Natural Resources Division

Project Review Summary

Prepared for the Environmental Advisory Board

PSDP-25-00426 - Michael Saunders Office Building - PID 0783080040

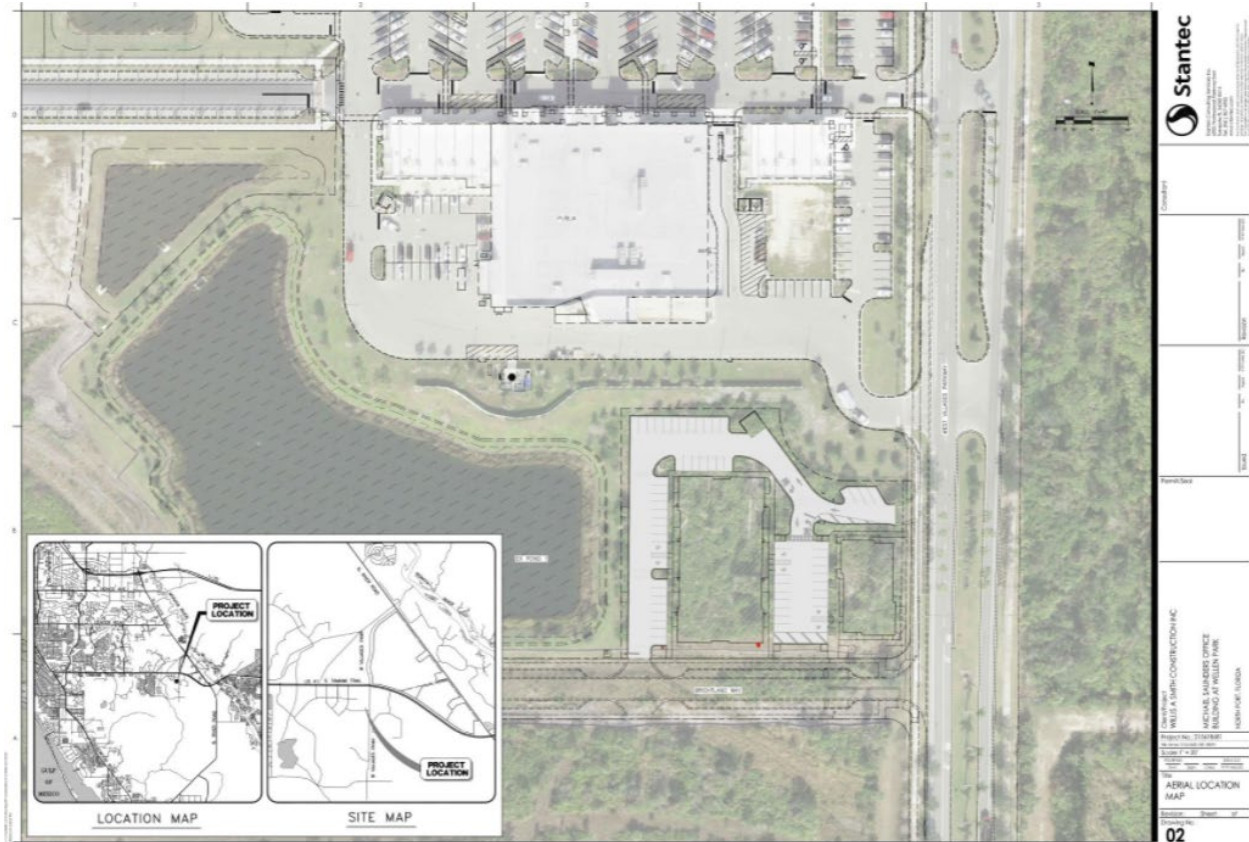
The application is missing key requirements related to the delineation of flood hazard areas and base flood elevations, as specified in the Unified Land Development Code. Additionally, the landscaping plan needs revision to address the limitations on solid building wall lengths and the necessary landscaping treatments for visible blank walls. Lastly, a Gopher Tortoise resurvey is required within 90 days prior to the commencement of development activities.

PSDP-25-00232 - Wellen Park Fire Station - PID 0807051000

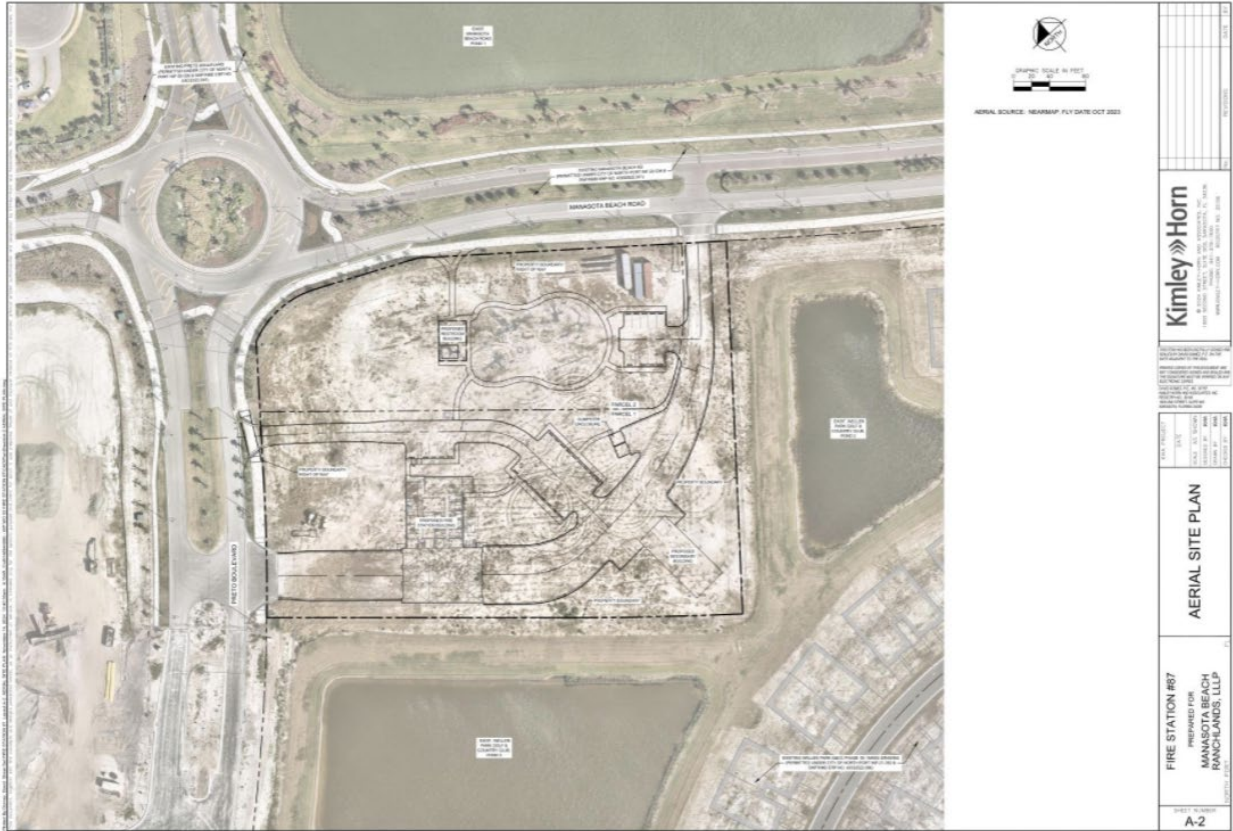
The required revisions include providing a signed irrigation plan from a certified irrigation technician or landscape architect. This plan should detail the type of irrigation system, application rates, and controller duration times for each zone. Additionally, there are no comments or concerns regarding the floodplain or arbor aspects of the project.
